DESCRIPTIVE REPORT

Type of Survey Hydrographic
Field No. RA-10-3-89
Registry No. H-10305

State Alaska
General Locality Alaska Peninsula
Sublocality Nakalilok Bay

Descriptive Report to Accompany Hydrographic Survey H-10305

16568

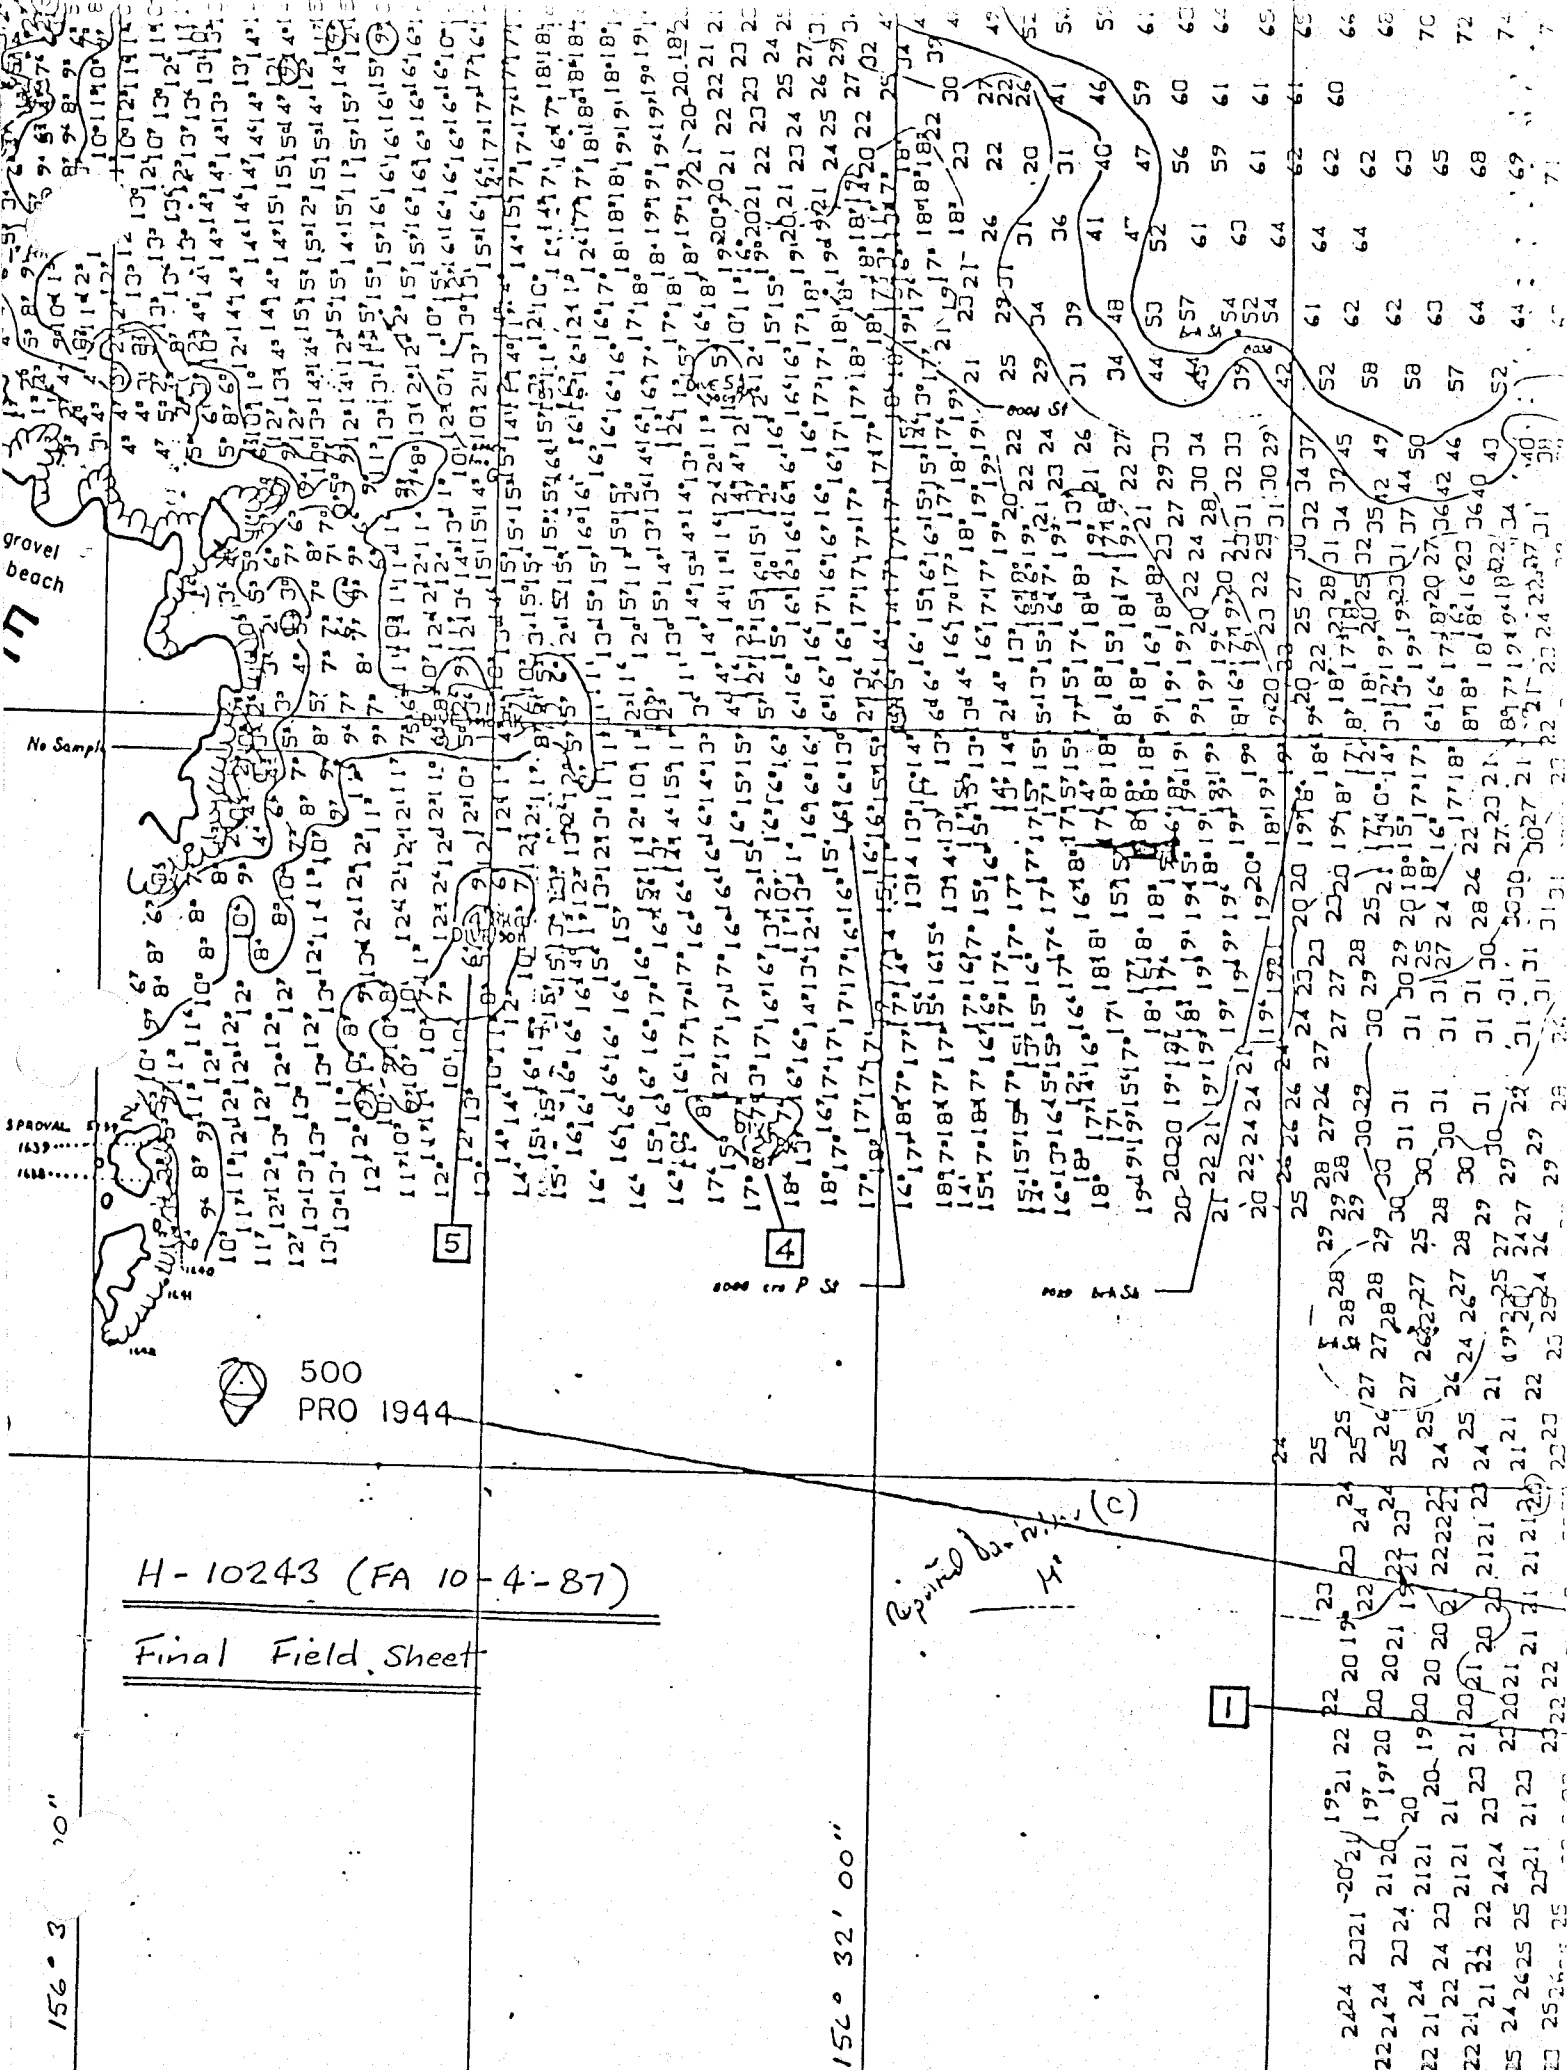
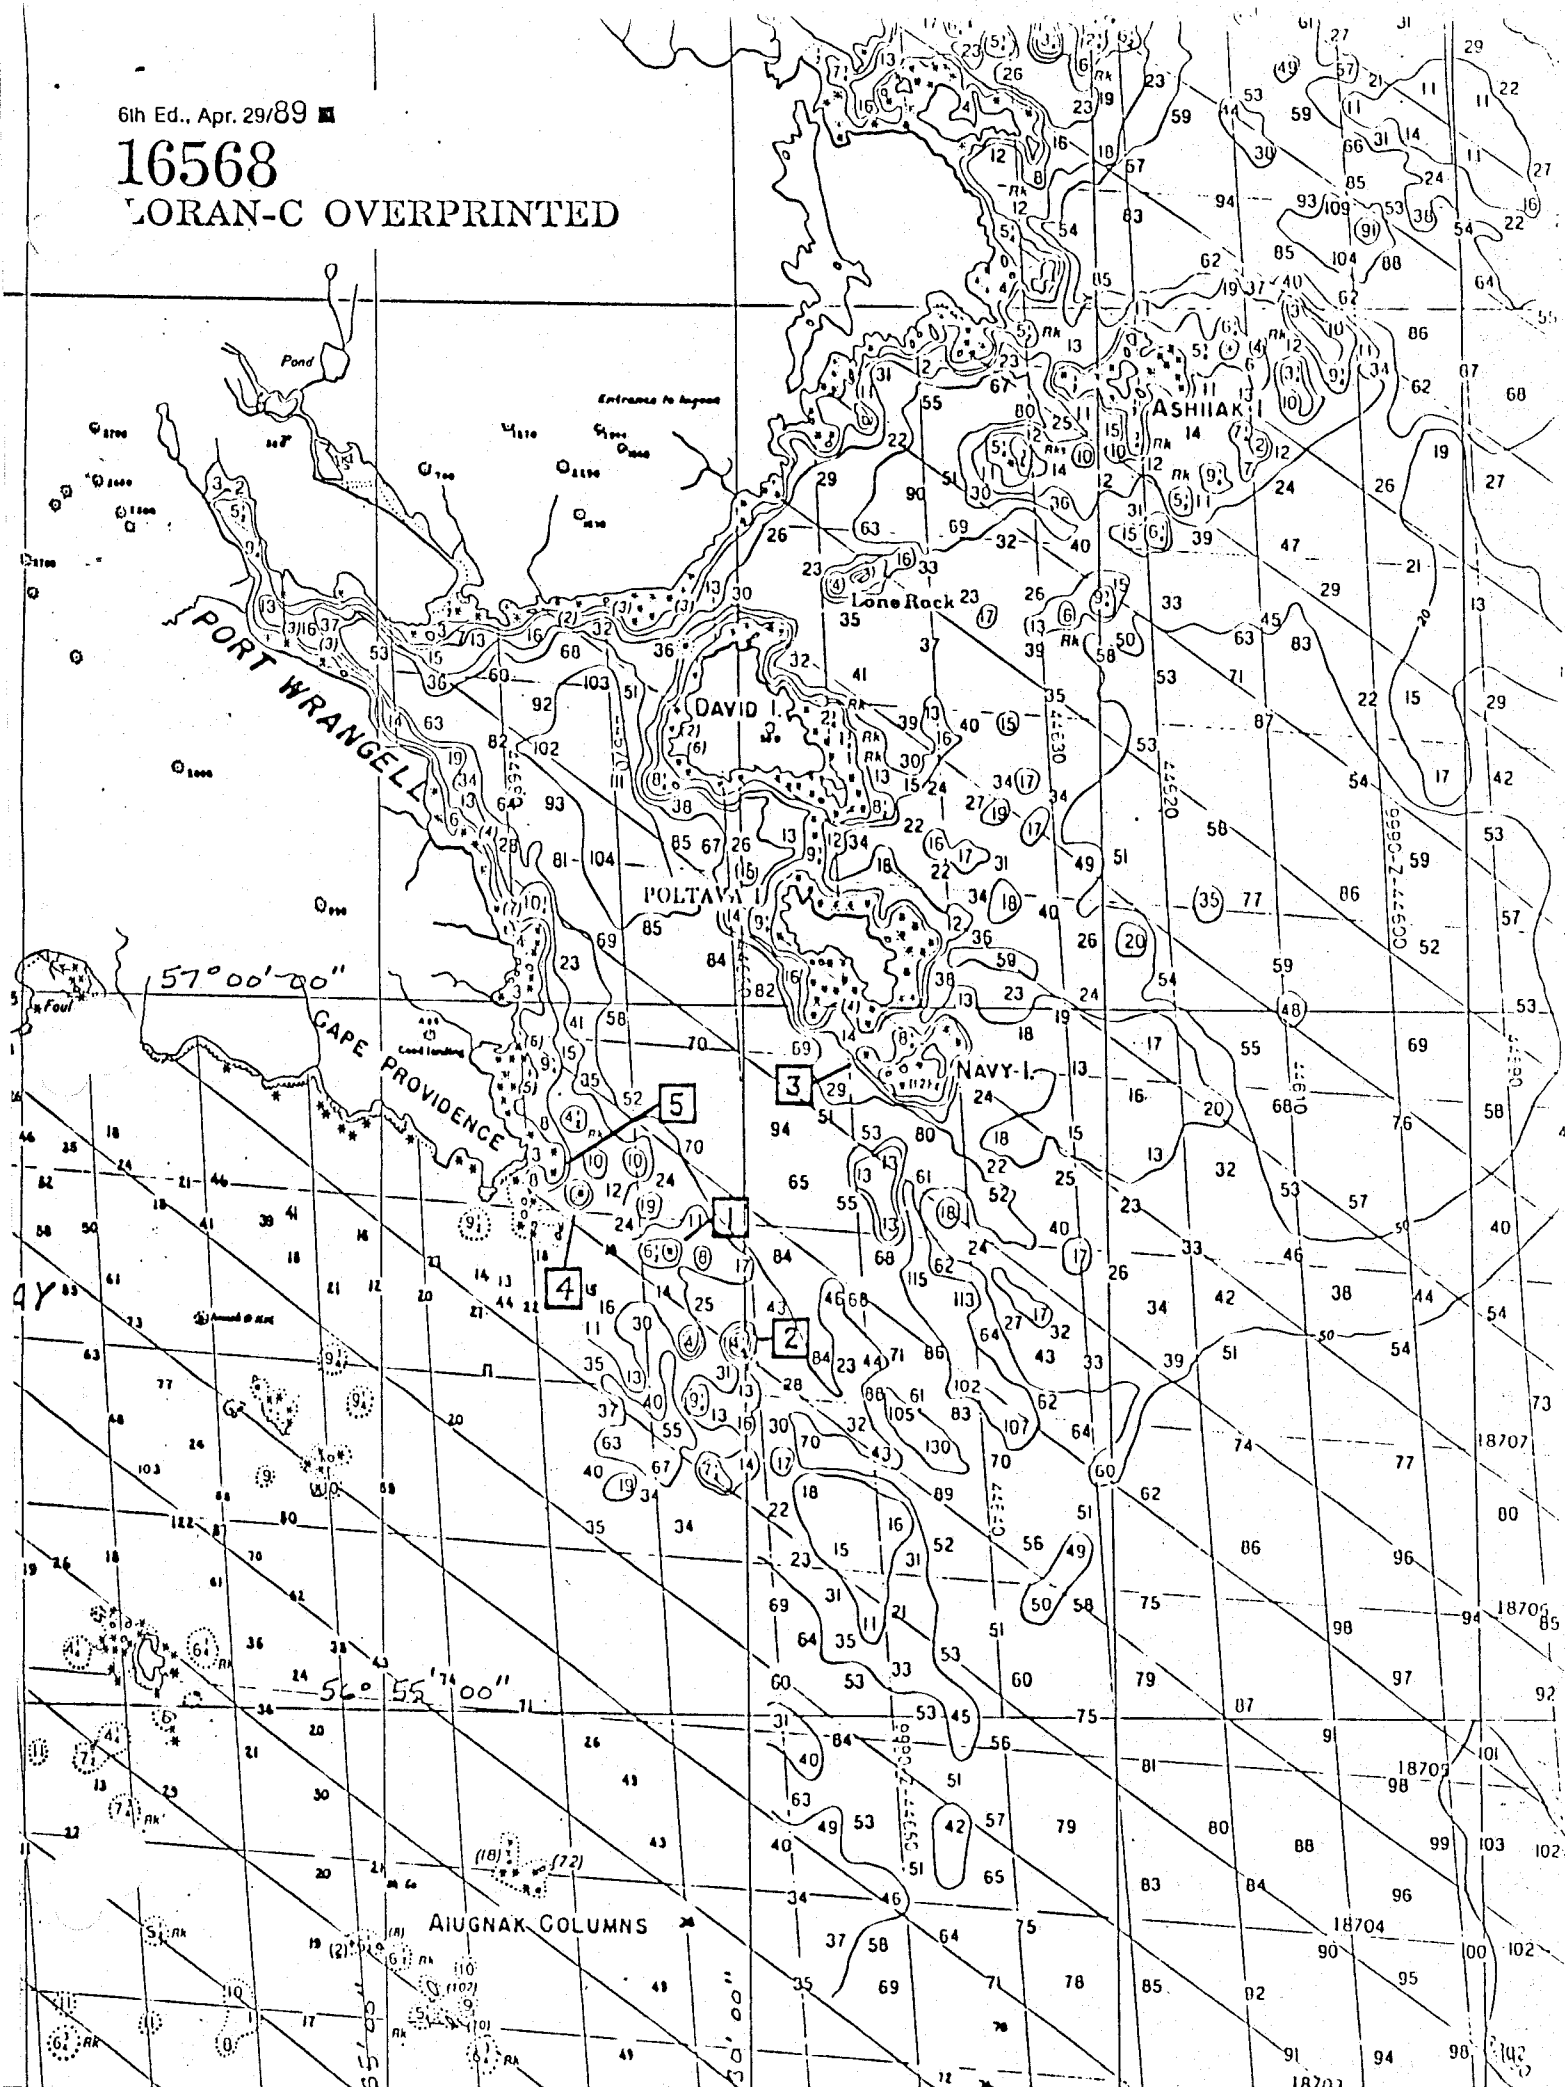
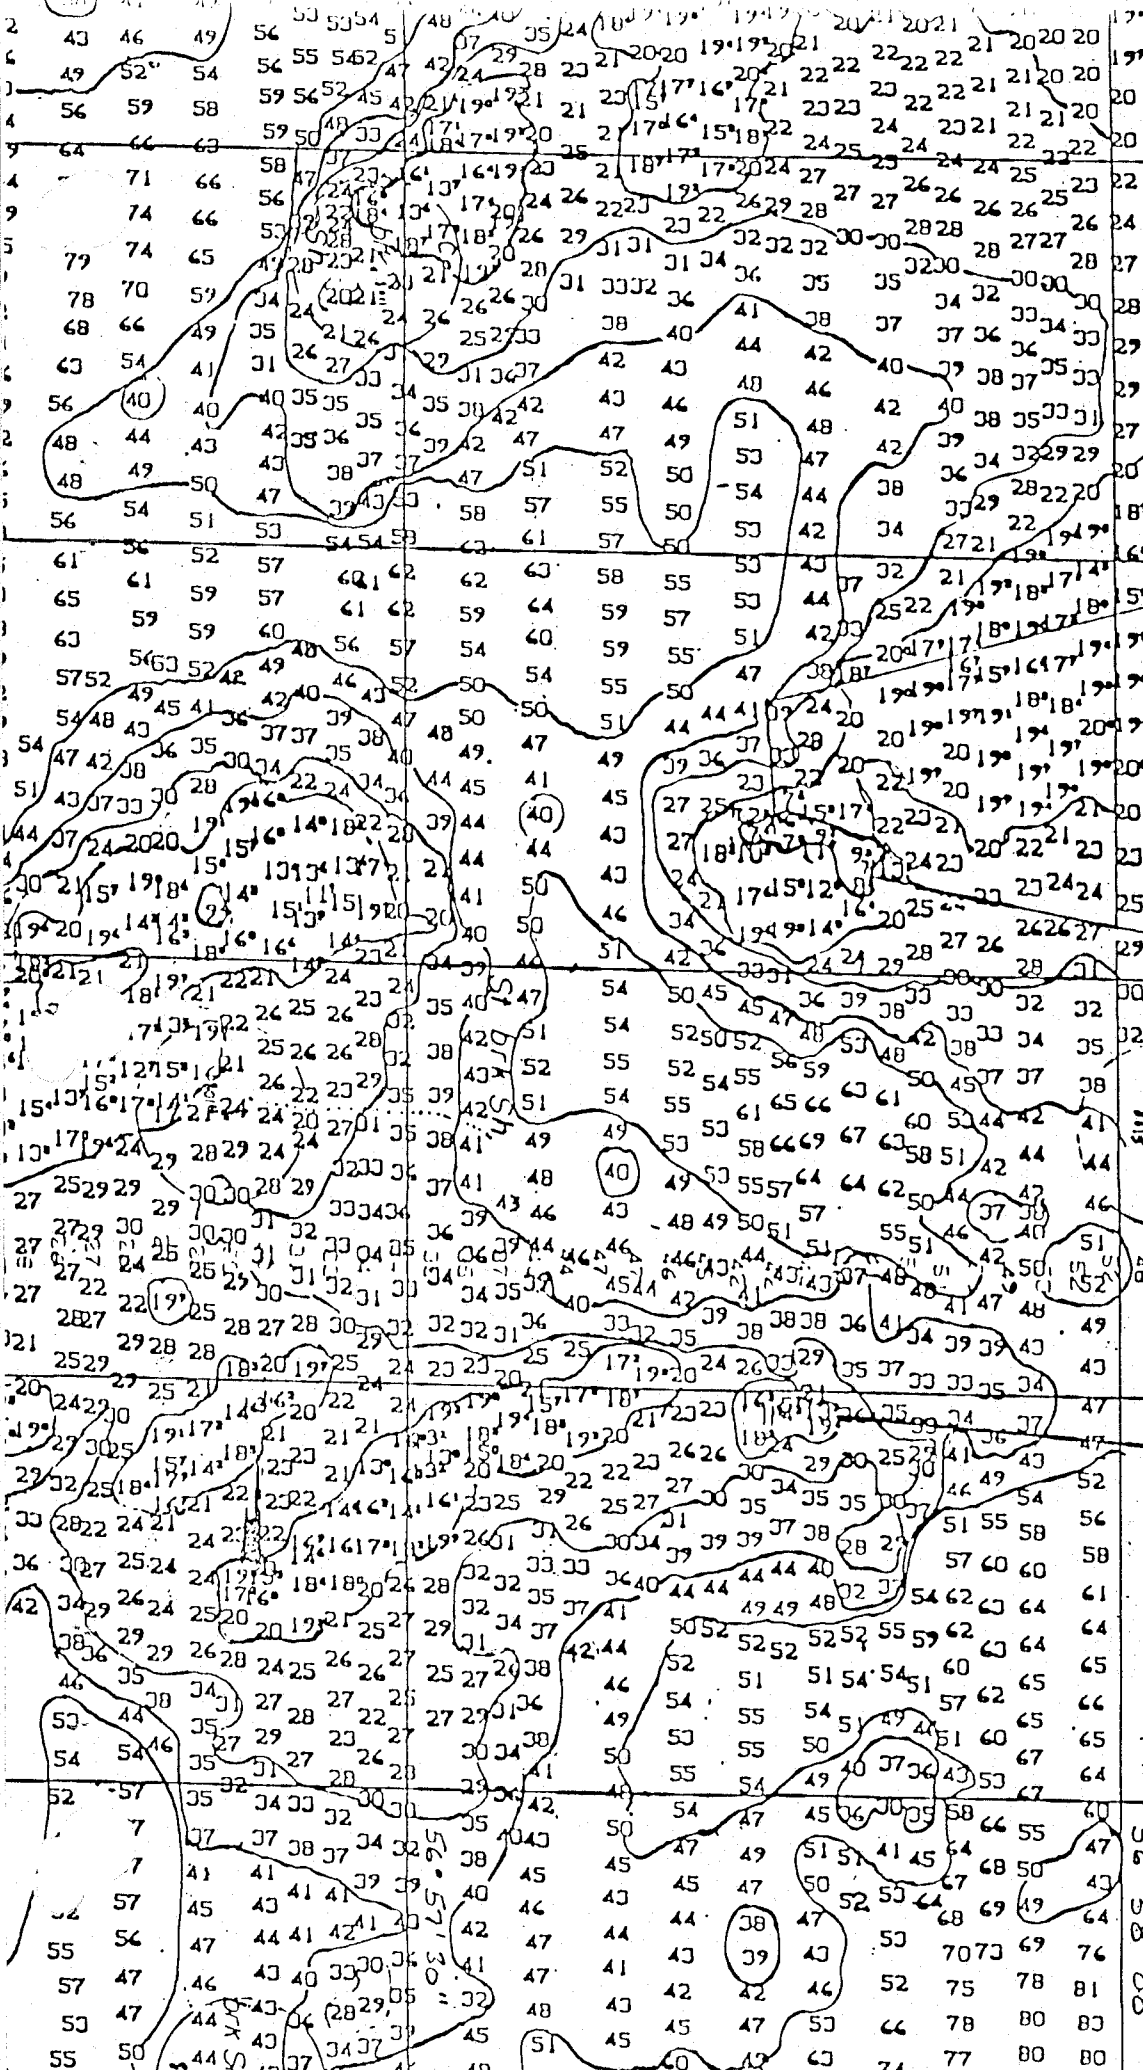
We recently received the new edition of Preliminary Chart 16568 which includes 1987 and previous survey data. A cursory comparison of the chart compilation with FAIRWEATHER field sheet H-10243 (1987) in the Cape Providence area raises several concerns. Either crucial survey data exists but was not shown on the final field sheet or excessive cartographic license was taken during chart compilation. The items below are numbered correspondingly on the attached copies of portions of Chart 16568 and survey H-10243.

1. Does a rock awash really exist at this location, as the chart indicates? Survey H-10243 shows only a least depth of 5.5 fathoms over a rock, as determined by divers. Last summer I selected a route into Chiginagak Bay which passed just south of this feature, between it and the 4-fathom shoal to the south, based on all information available on our copy of field sheet H-10243. Consequently, RAINIER has passed close aboard to this feature many times both last year and this, at various stages of tide. We've seen no evidence of a rock awash. The same is true of our launches and small boats working in the area. If this rock awash exists I will give this area a wider berth. If not, the chart should be revised to accurately portray the available depth.

2. The survey records need to be examined to determine if this feature really has a least depth of 4 1/4 fathoms, as charted. I suspect the true depth may be 14 fathoms. Close inspection of a mylar copy of the field sheet reveals that a "1" in front of the "4.2" may have been partially erased to make room for the hand-lettered "11.9." The sounding just to the west is 15.7 fathoms, the "1" just barely discernible on the mylar copy. Adding to my doubt is the absence of a dive investigation on this feature, even though a deeper sounding 0.4 n.m. west, 7.1 fathoms, was dove, and the fact that the feature was apparently not reported as a danger to navigation, as far as I can tell from the marginal notes. Also, the field sheet shows neither the 10- nor 5-fathom depth contours around this feature.

We have not been able to determine how the rocks awash, referred to in your memorandum of July 17, 1989, came to be charted on the 6th edition of chart 16568. The most likely explanation is a misinterpretation of the labels "Rk" on the survey.
